Corrigendum — CIBSE AM17

Corrigendum issued 19.07.23

Page 43, Figure 32

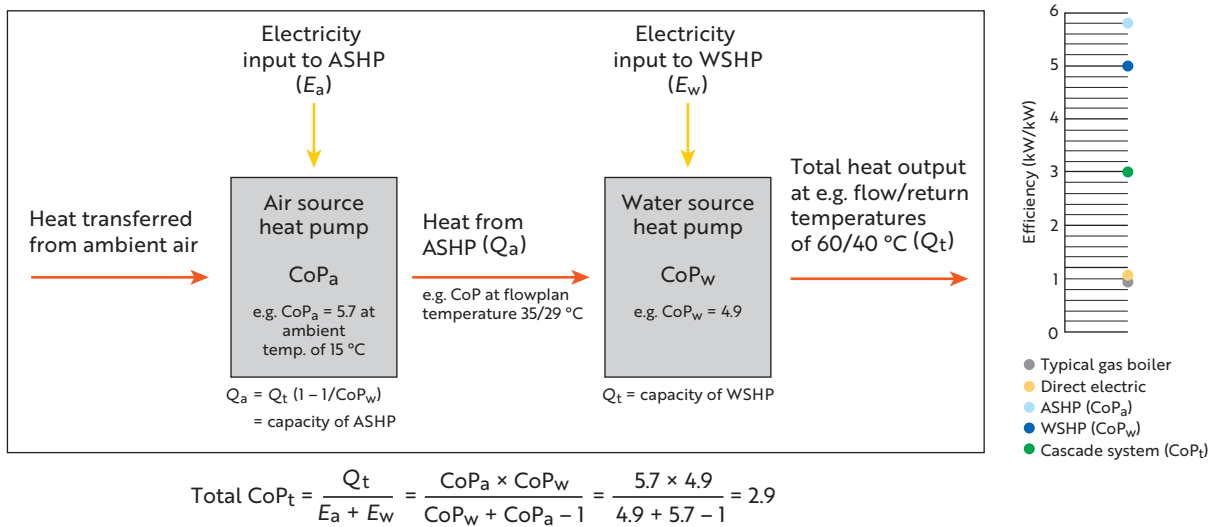
In left-hand grey box ('Air source heat pump'), CoP_s should read CoP_a (two occasions)

Text under right-hand grey box ('Water source heat pump'), Q_a should read Q_t

The corrected figure appears below.
